# Powers Engineering

## **Subject: Powers Engineering Comments on November 2008 RETI Phase 1B Draft Report**

**Figure 1. CEC projection in 2007 IEPR of impact of varying levels of energy efficiency (EE) on electric energy consumption by California utilities – yellow square represents achievement of 100% of cost-effective EE measures**

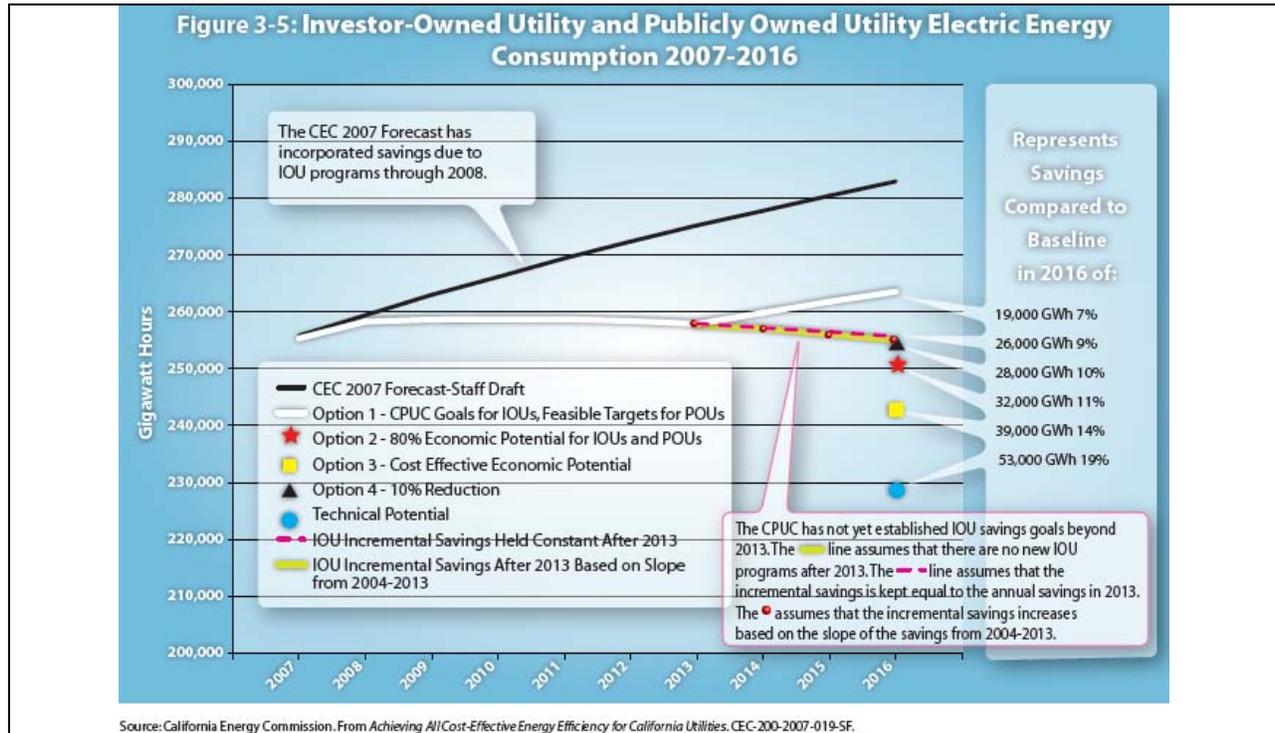
The CPUC issued landmark energy efficiency decision D.07-10-032 on October 18, 2007 that requires the IOUs to achieve 100 percent of cost-effective energy efficiency measures by 2020. The net effect of this decision will be an average absolute decline in annual energy usage between 0.5 and 1 percent per year from 2008 forward, and no growth in peak demand over time. The 100 percent of cost-effective energy efficiency forecast is represented by the yellow squares in 2016 in Figures 1 and 2 below. In practical terms this means that the 68,000 GWh “net short” assumed in RETI based on a 2020 demand of 335,000 GWh should be a “net short” of approximately 40,000 GWh based on a 2020 demand of approximately 230,000 GWh.<sup>25</sup>

<sup>25</sup> The 230,000 GWh value was determined by extrapolating the “100 percent cost-effective EE” line in Figure 1 from 2016 to 2020.

**Figure 3. Map of Transmission Lines Serving Southern California**

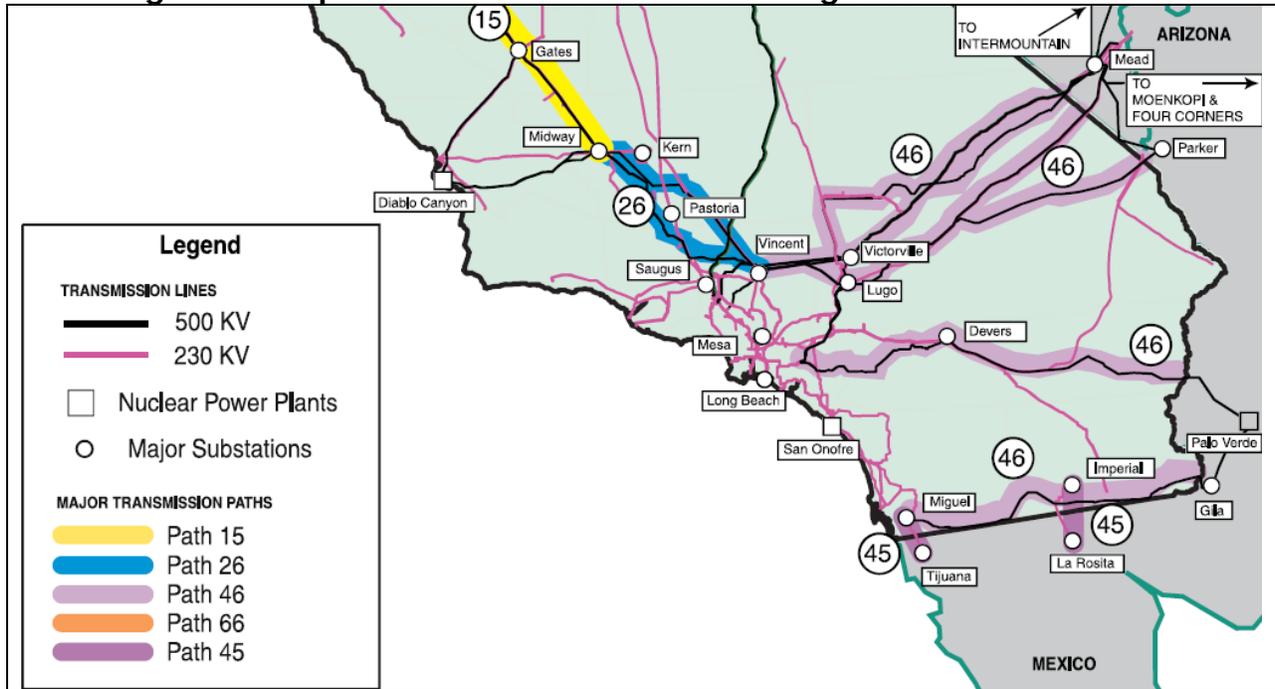
The fundamental presumption of the RETI process, that California has insufficient transmission infrastructure to meet a 33 percent RPS target, is incorrect. The focus of RETI is remote utility-scale renewable energy projects in Southern California. Southern California has approximately 15,000 MW of alternating current import capacity (Paths 26, 45, and 46) and 5,000 MW of direct current import capacity from the Columbia River and Utah. This is a total of 20,000 MW of import capacity. By way of comparison, the annual average combined retail sales load in SCE, LADWP, and SDG&E service territories is approximately 14,000 MW.<sup>29</sup> Southern California has the highest concentration of existing transmission lines in the state. Major Southern California transmission lines are shown in Figure 3.<sup>30</sup>

New radial high voltage transmission lines to reach high-value renewable energy areas, like the Tehachapi wind area, are justifiable given that without the transmission the renewable resource could not be developed. However, with the exception of the Tehachapi wind area, there is ample existing transmission serving high-value solar, wind, and geothermal areas in Southern California to reach the 33 percent renewable energy target by 2020. This is true even if the 33 percent target is reached exclusively by remote renewable energy production. Displacement of fossil-fuel imports with renewable energy on existing transmission lines must be a fundamental objective of RPS compliance to minimize costs to California's ratepayers.
